<p><b>Reigate &amp; Banstead</b> BOROUGH COUNCIL Banstead   Horley   Redhill   Reigate</p>	<b>TO:</b>	PLANNING COMMITTEE
	<b>DATE:</b>	4 October 2017
	<b>REPORT OF:</b>	HEAD OF PLACES & PLANNING
	<b>AUTHOR:</b>	Rosie Baker
	<b>TELEPHONE:</b>	01737 276173
	<b>EMAIL:</b>	rosie.baker@reigate-banstead.gov.uk
<b>AGENDA ITEM:</b>	7	<b>WARD:</b> Redhill West

<b>APPLICATION NUMBER:</b>	17/01403/F	<b>VALID:</b>	<b>22.06.2017</b>
<b>APPLICANT:</b>	Executors of the Estate of Marjorie Eames	<b>AGENT:</b>	Martin Steele Partnership
<b>LOCATION:</b>	<b>42 CARLTON ROAD, REDHILL, SURREY RH1 2BX</b>		
<b>DESCRIPTION:</b>	<b>Demolition of the existing property with outbuildings and construction of three new four bedroom detached houses with off street parking and associated works. As amended on 11/08/2017</b>		
<b>All plans in this report have been reproduced, are not to scale, and are for illustrative purposes only. The original plans should be viewed/referenced for detail.</b>

# 17/01403/F - 42 Carlton Road, Redhill

Mr + Mrs A Whitfield · 42 Carlton Road Redhill RH1 2BX · **Proposed Site Layout · 805 · 12B**  
**Martin Steele Partnership Architects** · Feb 17 · 1:200@A1 [1:400@A3] · **Planning Consent Only**

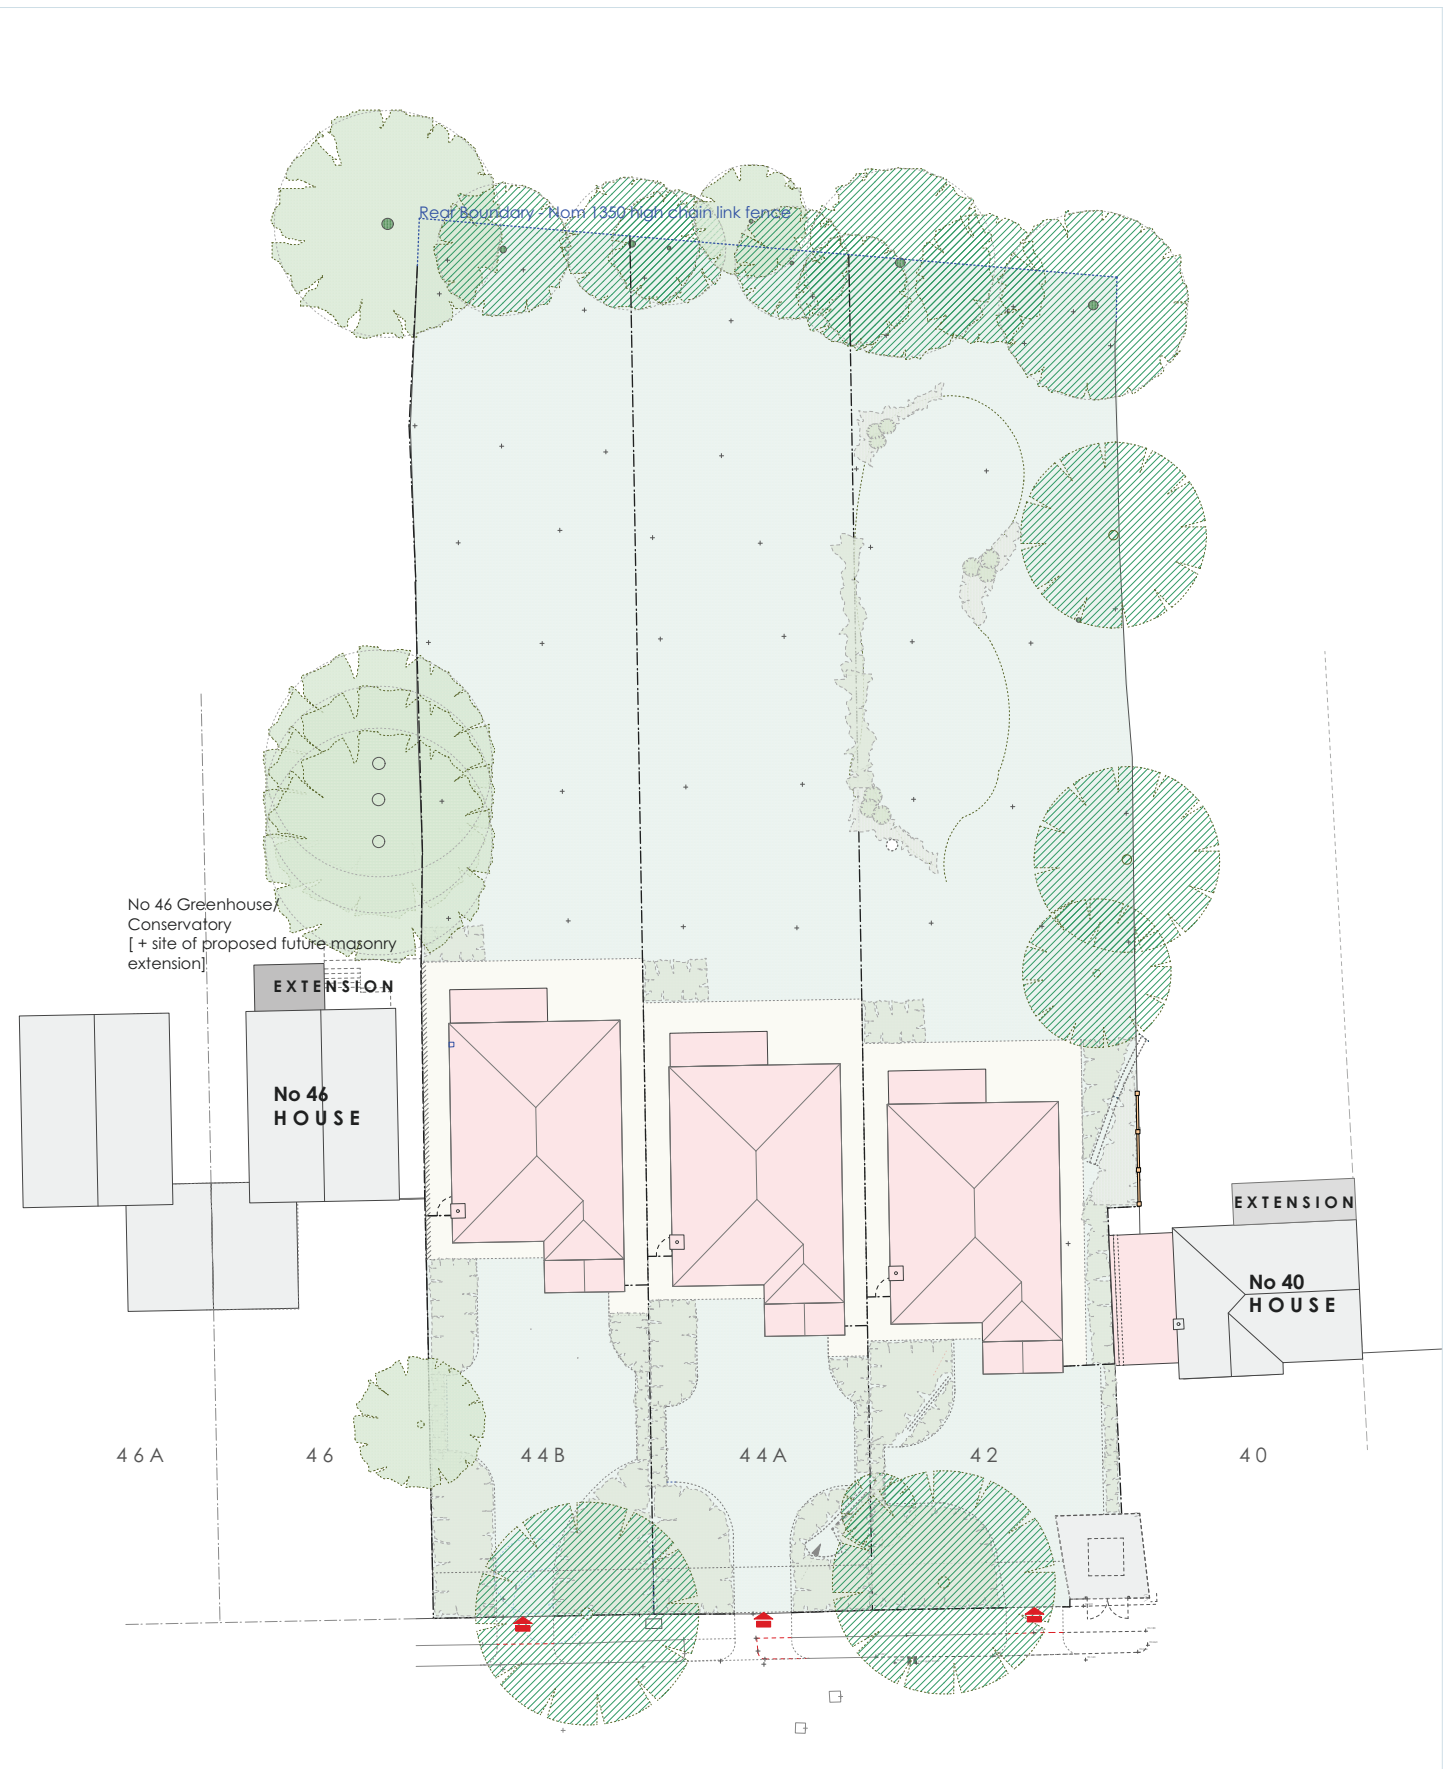
- 6.12 The original plans were considered to cause harm by reason of overbearing and dominance to the amenities of the neighbouring property at no.46 given the extent of forward projection of proposed dwelling 44B. In addition the proposed return glazing fenestration on all three dwellings was considered unneighbourly with regards to loss of privacy and overlooking.

- 6.13 Revised plans were subsequently submitted with proposed dwelling 44B set back a further metre and proposed dwelling 44A set back by 500mm. All return glazing has been removed. The forward projection has been reduced to approximately 2m and is now considered acceptable. Whilst the amendment has resulted in proposed dwelling 44B sited further to the rear it will not extend beyond the existing rear building line of no 46.

REV B 2017 08 08: PROPOSED 44B SET BACK A FURTHER 1M - (PREVIOUSLY SET BACK 1350 DURING DESIGN DEVELOPMENT); PROPOSED 44A SET BACK 0.5M; CORNER WINDOWS CHANGED; NOTE B ADDED.  
REV A 2017 04 08: UPDATE TO A1A
